# Proposed Revisions to a Standard Plans Index

(Please provide all information — Incomplete forms will be returned)					
Contact Information:			<b>Standard Plan</b>	Standard Plans:	
Date: January 14, 2020			Index Number:	Index Number: 515-022	
Originator: Cheryl Hudson			Sheet Number (s)	Sheet Number (s): 3	
Phone: 414-5332		Index Title: Pede	Index Title: Pedestrian/Bicycle Bullet Railing Details		
Email:	cher	yl.hudson@dot.state.fl.us			
<u>Sumr</u>	mary	of the changes:			
Add	ded No	ote 3D			
Commentary / Background:					
Added clarity to the types of anchor bolts applicable					
Added clarity to the types of another boiles applicable					
Other Affected Offices / Documents: (Provide name of person contacted)					
Yes	No	ected offices / Documents.	ne or person contacted	4)	
	V V V V V V	Other Standard Plans –			
		FDOT Design Manual –			
		Basis of Estimates Manual –			
		Standard Specifications –			
		Approved Product List –			
		Construction –			
		Maintenance –

515-022 3 of 3

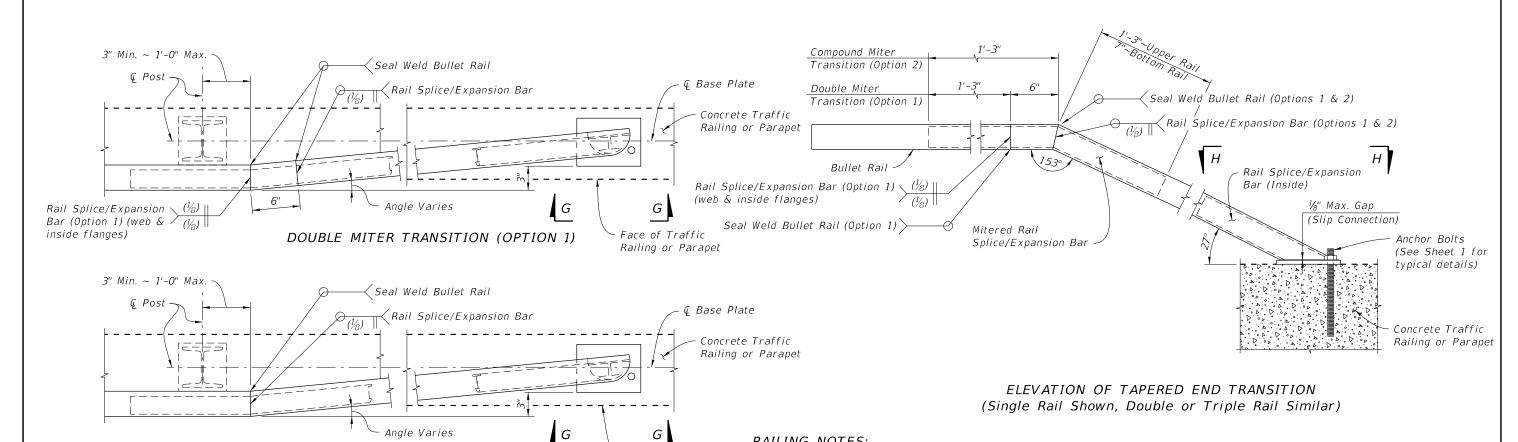
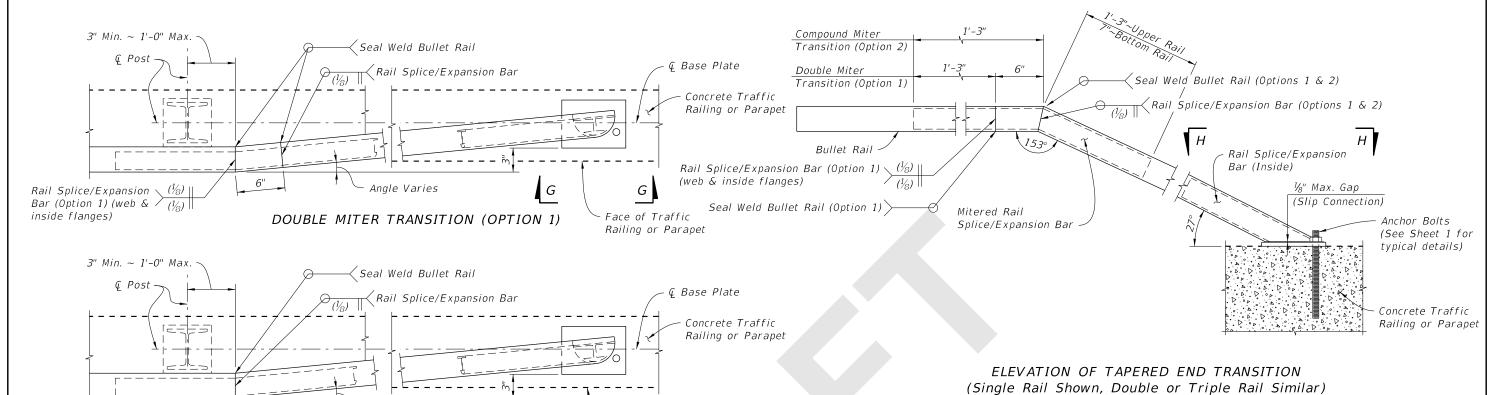
D. Anchor Bolts: Galvanized ASTM A307 Grade 36 Hex Head. ASTM 1554 Grade 55 Threaded Rods for Adhesive **Anchors**

- D. Anchor Bolts: Galvanized ASTM A307 Grade 36 Hex Head, Galvanized ASTM 1554 Grade 55 Threaded rods for Adhesive Anchors.
- Layout.
  - A. Posts shall be uniformly spaced with reasonable consistency.
